TRACT MAP NO. 73336

TENTATIVE MAP DATED <u>06/15/16</u> EXHIBIT MAP <u>06/15/16</u>

MAJOR SUBDIVISION **VESTING TENTATIVE** TRACT NO. 073336

GRADING

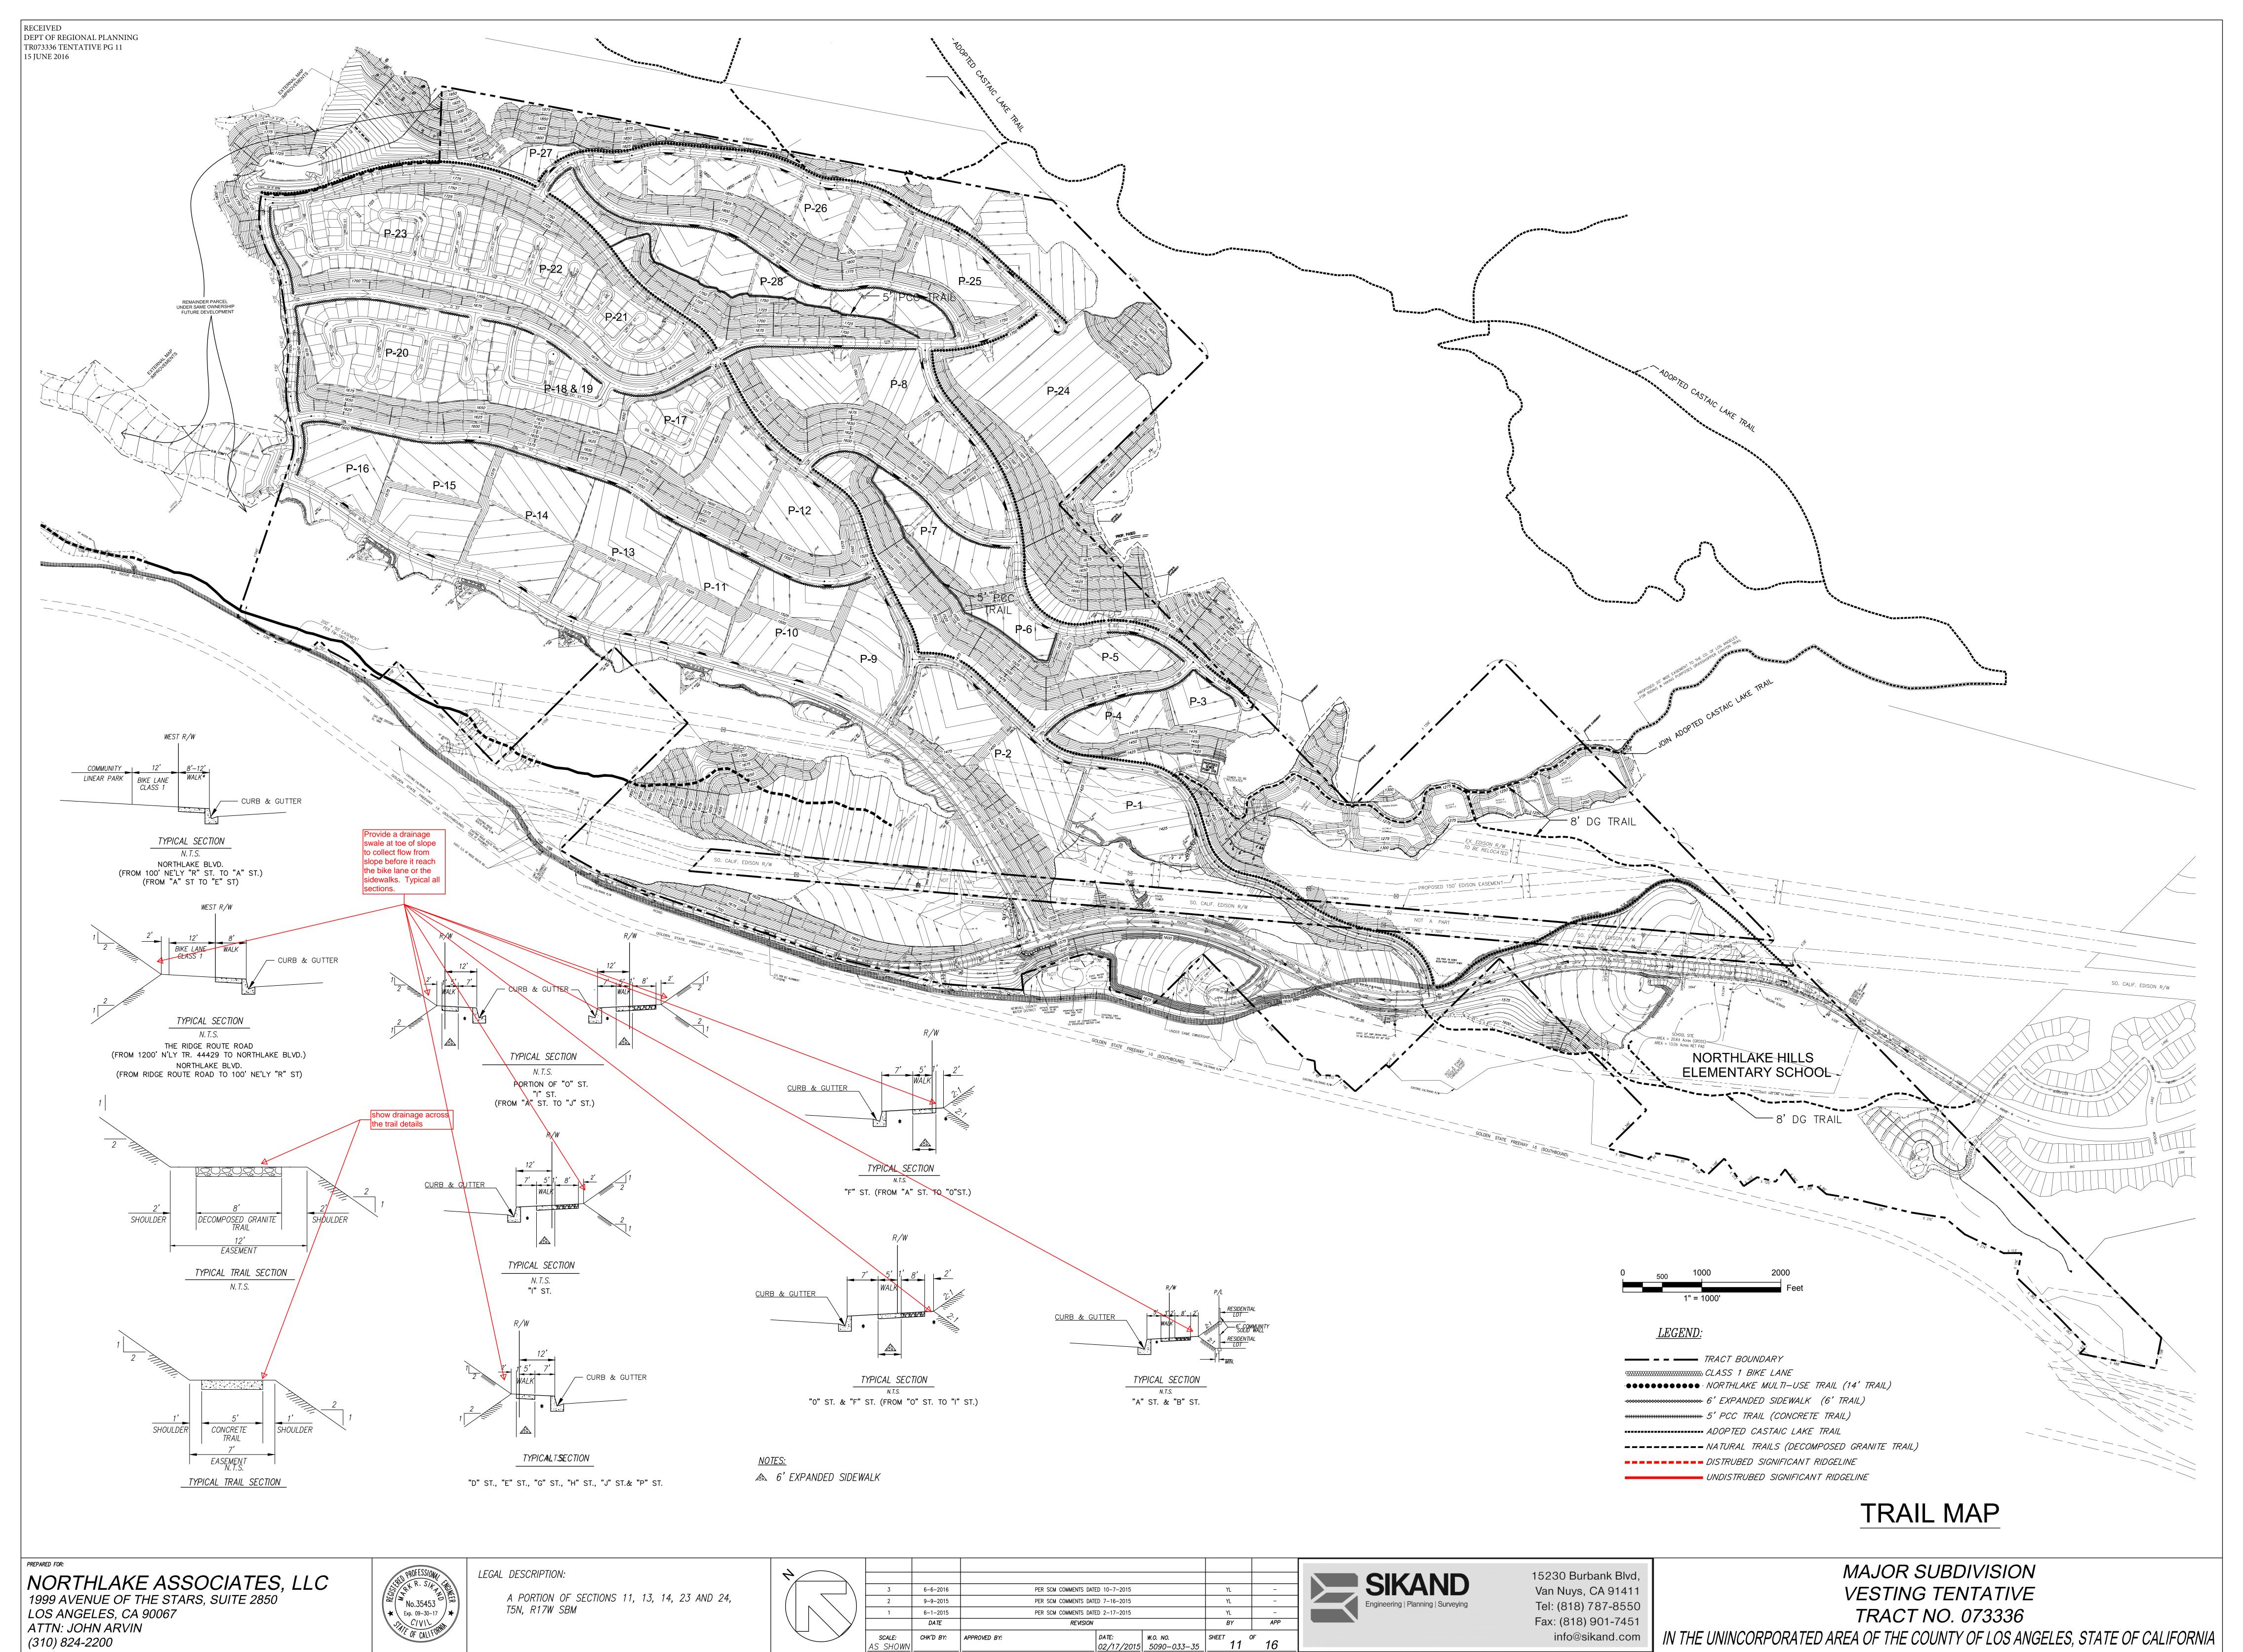
- 1. A revised tentative map is required to show the following additional previously requested items:
 - a. Curb face height for the private driveway and fire lane.

- b. Catchment areas and devices that expected to receive desilted debris and required periodic maintenance. These areas and devices must be accessible.

- c. More contour line elevations
 - d. Identify the maintenance responsibility (Public or Private) of all basins.
 - e. Drainage device at tow of slopes 5' or higher adjoining right of way of a section with sidewalks at right of way lines to avoid runoff or irrigation flow to the sidewalks.

- 2. Approval of the latest drainage concept/hydrology study/water quality plan by the Storm Drain and Hydrology Section of Land Development Division.
- 3. Emergency overflow of debris basin 371 and 380 are not properly designed. The adjoining improvements may be flooded.

- 4. Provide minimum 3 feet wide terrace on top and outside the easement limit or fee lot lines of all publicly maintained basins to separate slopes to be maintained within the basin from the slope to be privately maintained outside the basin.

- 5. Additional Comments in red on the attached tentative map.

ROAD

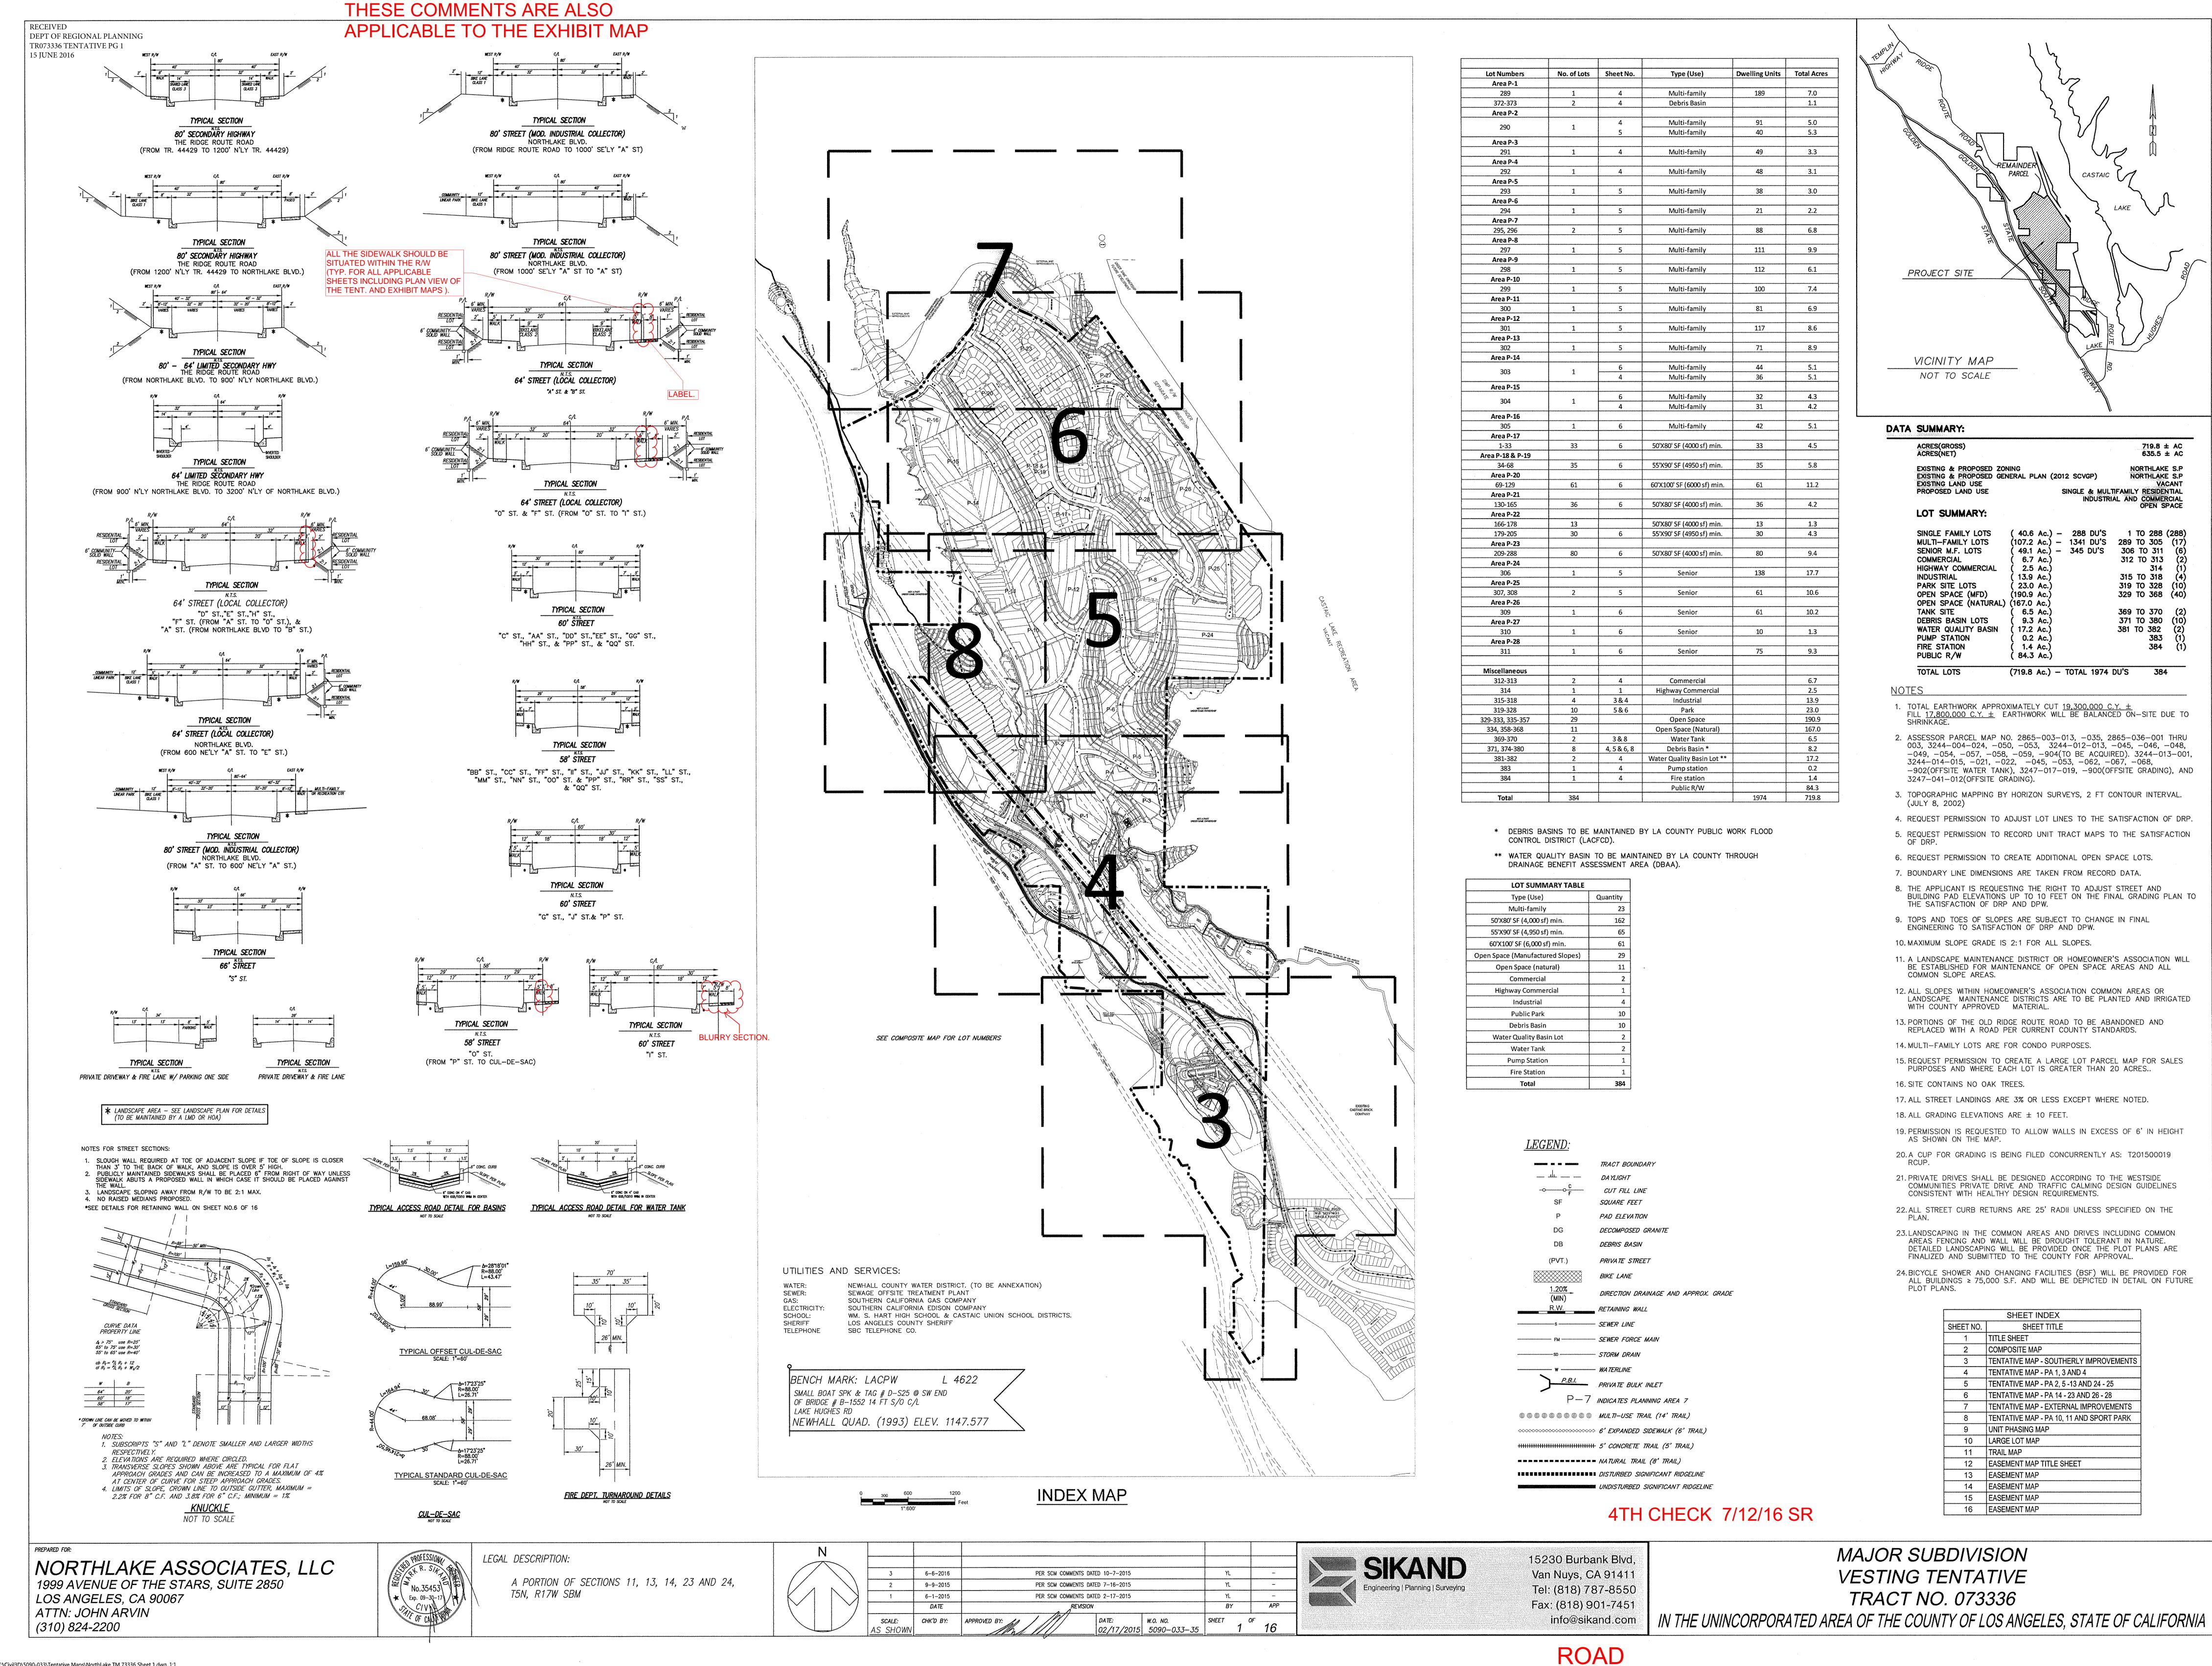
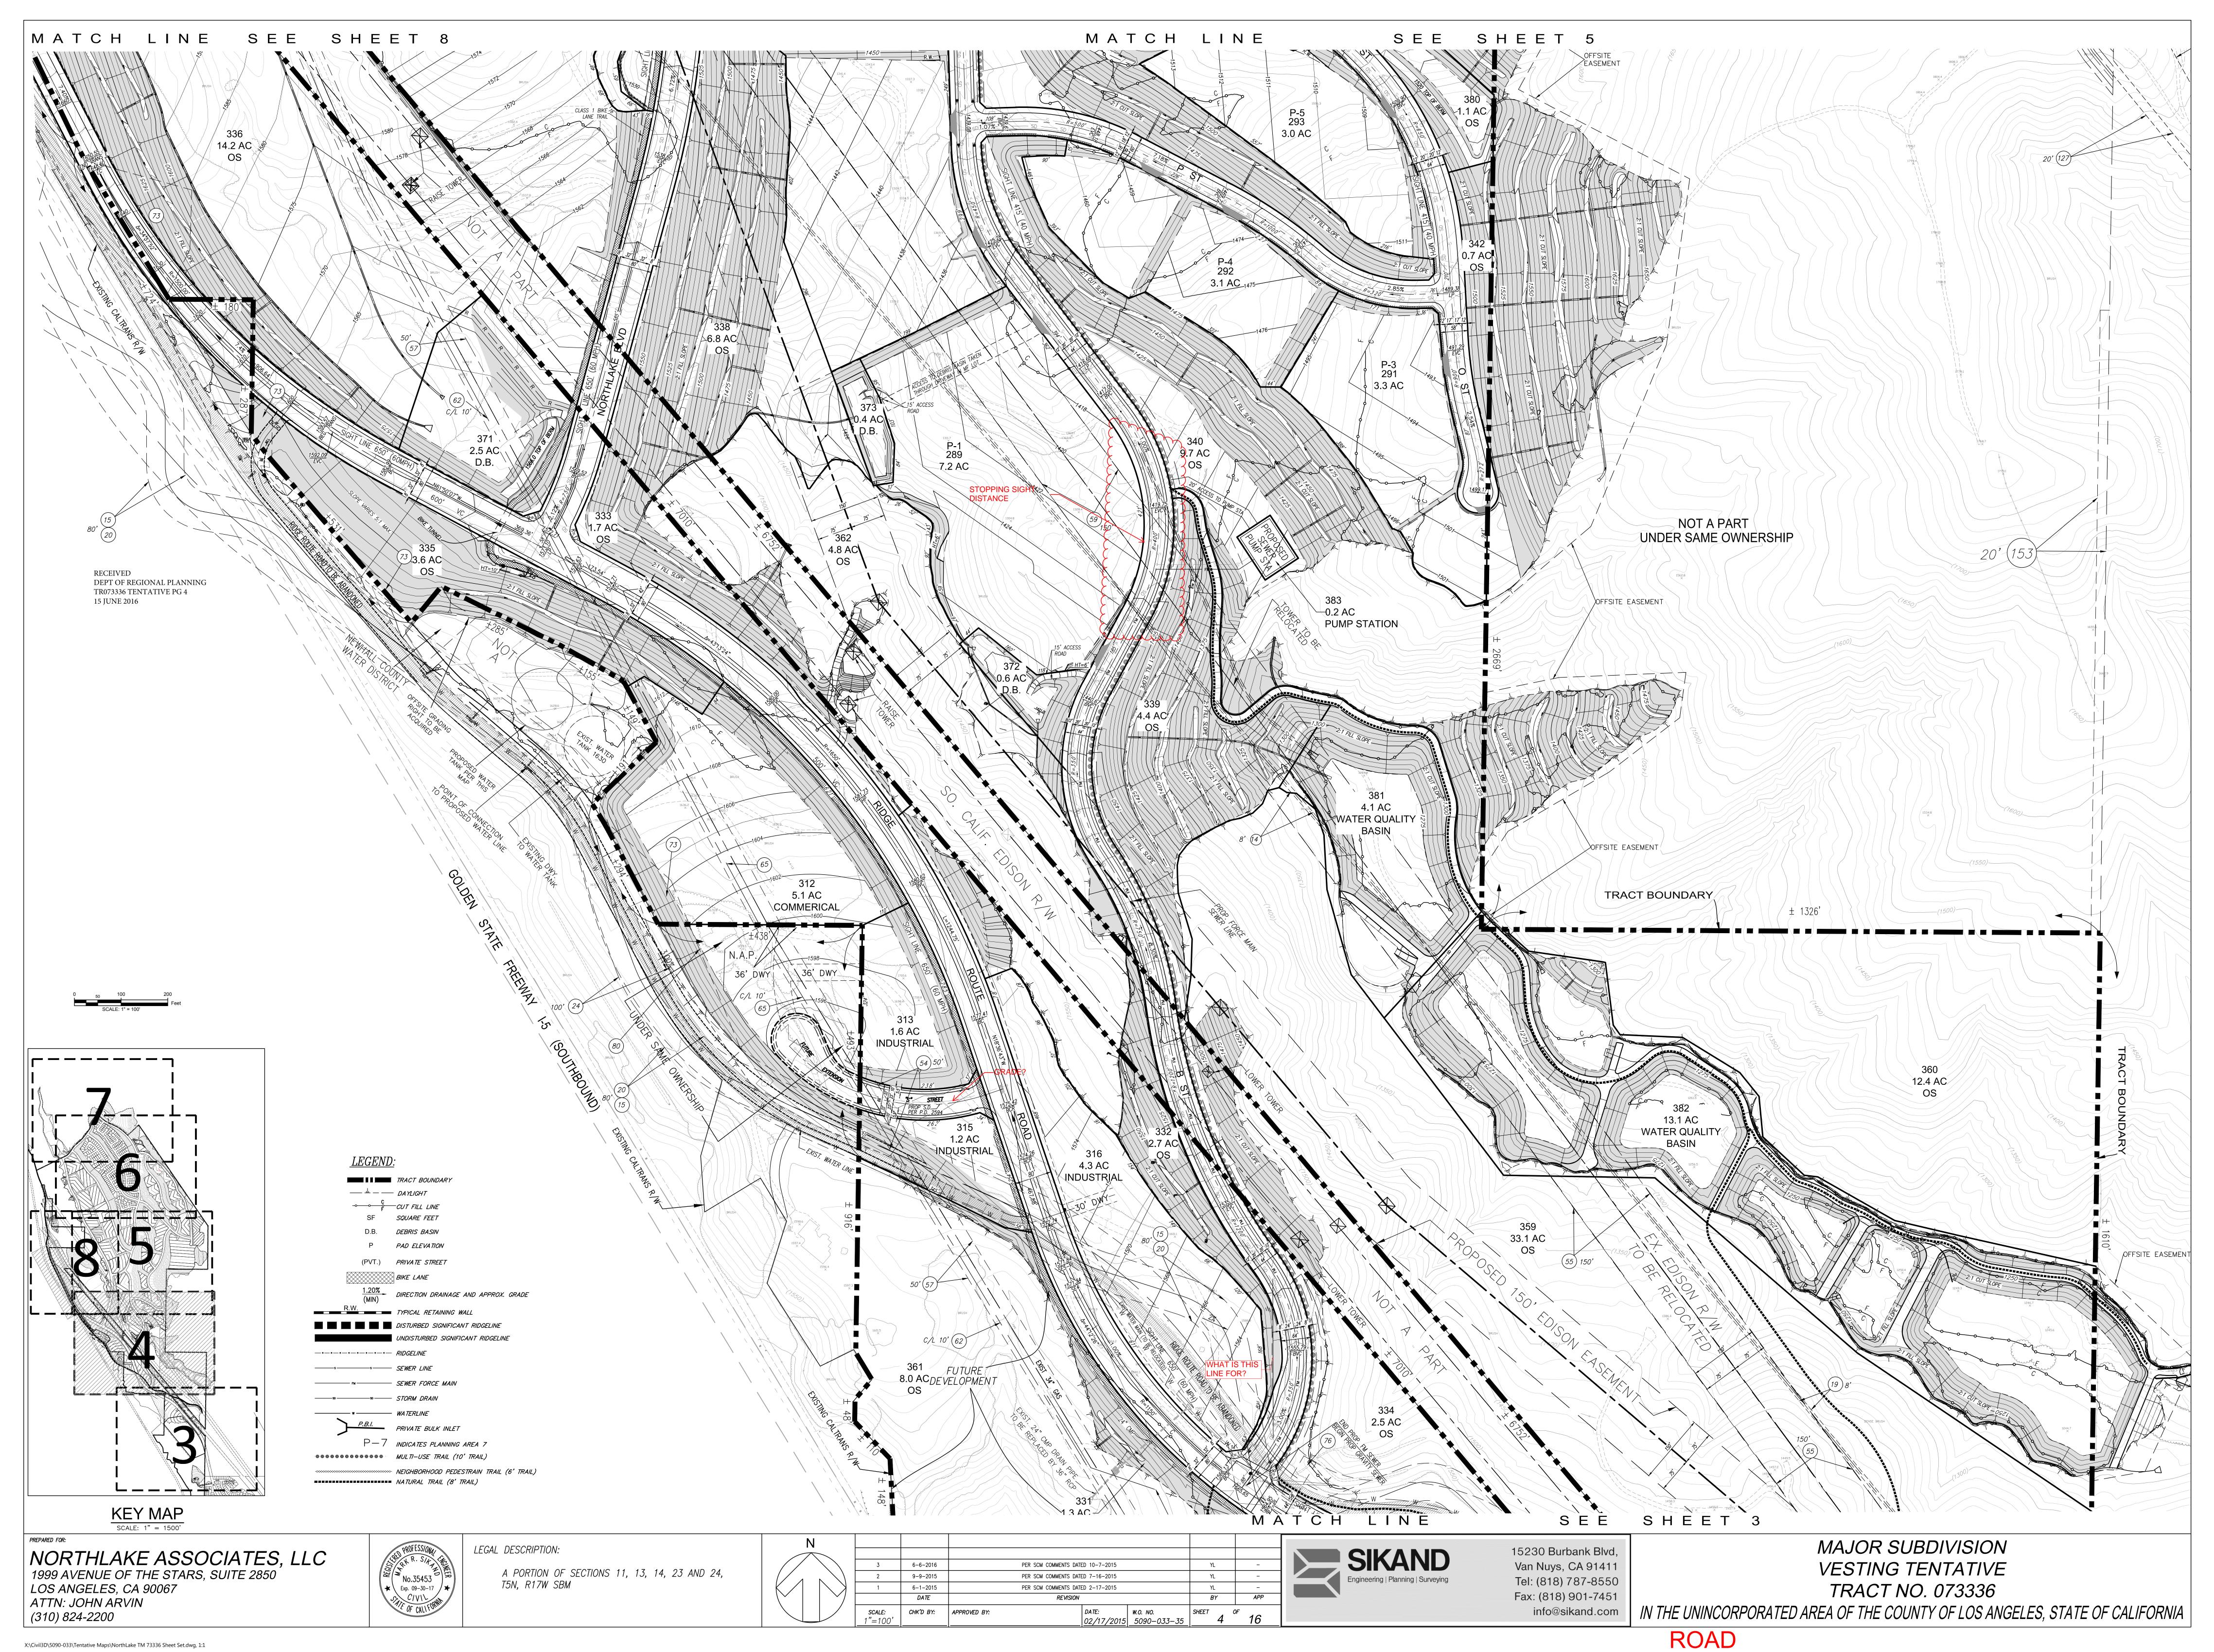
- 1. Traffic Study will be required. Please contact Andrew Ngumba of Traffic and Lighting Division, Traffic Study section at (626) 300 4851 for requirements.
- 2. A revised tentative map and exhibit map are required to show the following items:
  - a. See attached for comments.
